REQUEST FOR INFORMATION	DATE: May 03, 2016	NO.: RFI-058
--------------------------------	---------------------------	---------------------

Project Name: Webster University Interdisciplinary Science Building Project No.: 15051

Subject: Framing detail at discontinued column at Level 3

CONCEPTUAL NON-SEISMIC MOMENT CONNECTION

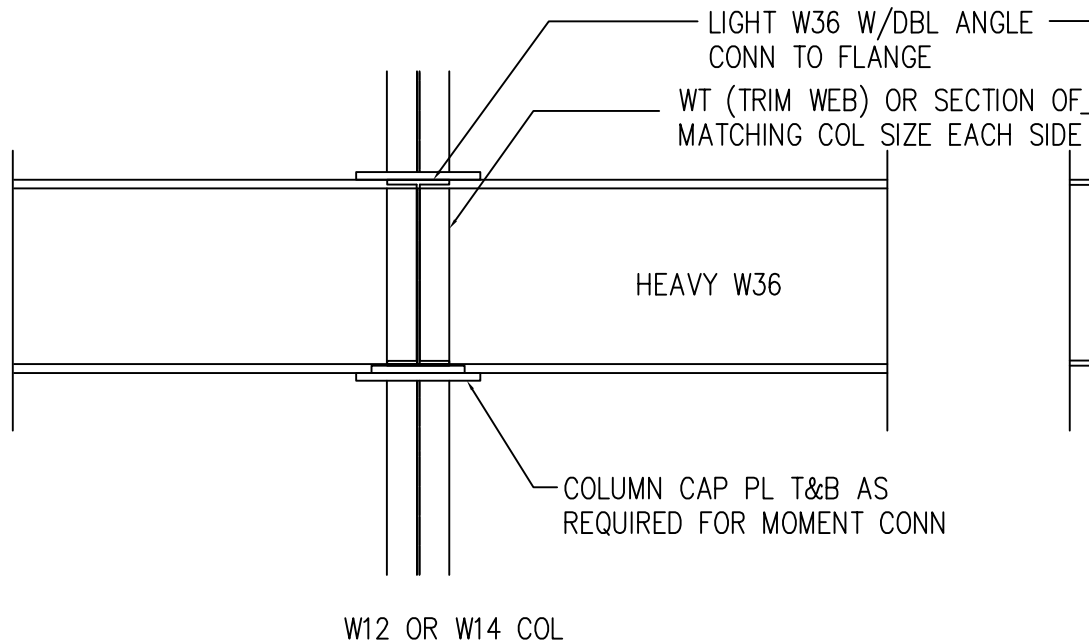
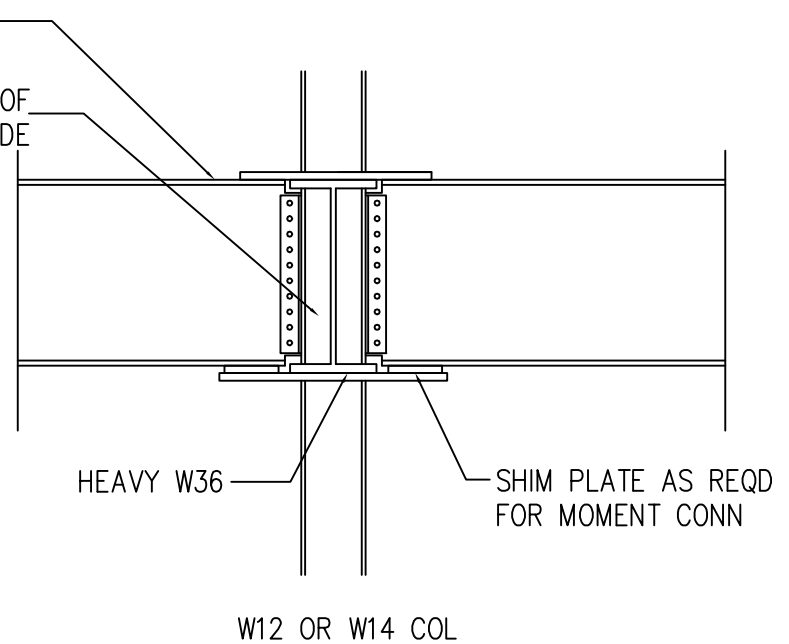
Please specify the framing detail for discontinuous columns over deep girder at A.2-1.6, A.5-1.6, B.3-1.6, and C-1.6.

SEE ATTACHED CONCEPTUAL DETAIL.
